Errata No. 1
 SEAOC “Recommended Lateral Force Requirements and Commentary”
 1999, Seventh Edition

Figure C402-5. Punching shear criterion of §1921.7.5.

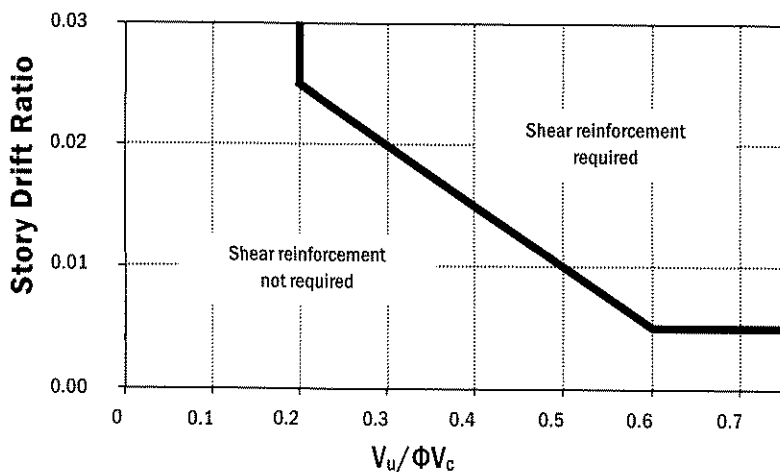
Page 210, Reinforced Concrete.

Add a new Figure C407-5:

The procedure for checking slabs at columns does not require a calculation of induced moments, and instead is based on (a) the story drift corresponding to the lateral design displacement, and (b) the level of gravity-load shear stress on the punching-shear perimeter. Figure C402-5 illustrates the criterion of Section 1921.7.5, which

requires shear reinforcement to be provided where the combined effect of story drift and shear stress could result in a punching shear failure. The criterion derives from test data of slabs subjected to gravity load and lateral displacement [Megally and Ghali 2000, Pan and Moehle 1992].

Figure C109-1. Nonbuilding structures supported above grade ($W_p < 0.25 W_s$)

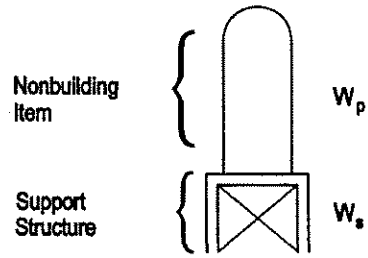
Page 170, Figure C109-1.

Delete the existing figure and insert revised Figure C109-1 given at the end of this errata.

Figure C109-2. Nonbuilding structures supported above grade ($W_p > 0.25 W_s$)

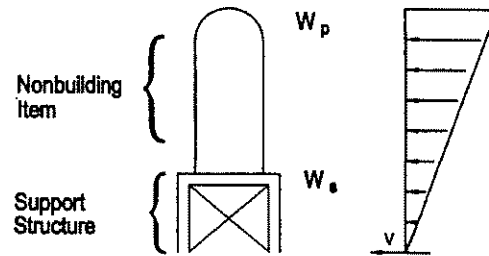
Page 171, Figure C109-2.

Delete the existing figure and insert revised Figure C109-2 given at the end of this errata.
